Intersection ID: 26427	Main Street: BALLINARD_LN	Cross Street: ENCLAVE_PL	Location:	SW
ADA ID: BD9B2982C96F	Ramp Type: PerpDiag	Initial Pass/Fail: Fail	Overall Compliance: No	Severity Score: 13.75

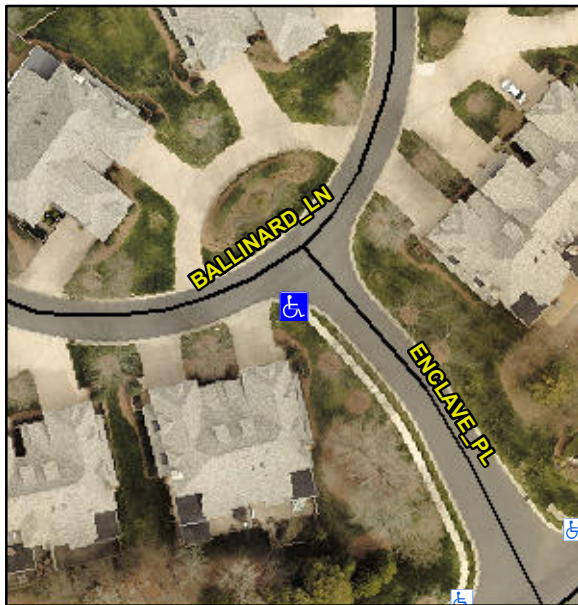
**Not Found, R304.2.2, R304.5.3**

Compliance	Description	Data	Compliance	Description	Data
N/A	Ramp Length (in)	35.0	No	Ramp Slope (%)	9.2
Yes	Ramp Width (in)	48.0	No	Ramp XSlope (%)	2.6
N/A	Flare Type LT	N/A	N/A	Flare Type RT	N/A
N/A	Flare Slope LT (%)	N/A	N/A	Flare Slope RT (%)	N/A
N/A	Flare Traversable LT?	N/A	N/A	Flare Traversable RT?	N/A
N/A	Landing Length (in)	N/A	N/A	DWS Provided?	N/A
N/A	Landing Width (in)	N/A	N/A	DWS Contrast?	N/A
N/A	Landing Slope (%)	N/A	N/A	DWS Length (in)	N/A
N/A	Landing X Slope (%)	N/A	N/A	DWS Full Width?	N/A
N/A	Landing Curb? (Y/N)	N/A	N/A	DWS Offset (in)	N/A
N/A	Shared Landing?	N/A			
N/A	Gutter Ponding?	N/A	N/A	Gutter Slope (%)	N/A
N/A	Gutter Lip Ht (in)	N/A	N/A	Gutter X Slope (%)	N/A
N/A	Painted X Walk1?	No	N/A	Painted X Walk2?	No
	X Walk 1 Direction	To NE		X Walk 2 Direction	To N
N/A	X Walk 1 Width (in)	N/A	N/A	X Walk 2 Width (in)	N/A
	X Walk 1 Slope (%)	5.6		X Walk 2 Slope (%)	6.2
	X Walk 1 X Slope (%)	4.1		X Walk 2 X Slope (%)	3.1

**Remove & Replace Curb Ramp With Two New Directional Ramps or Equivalent.**
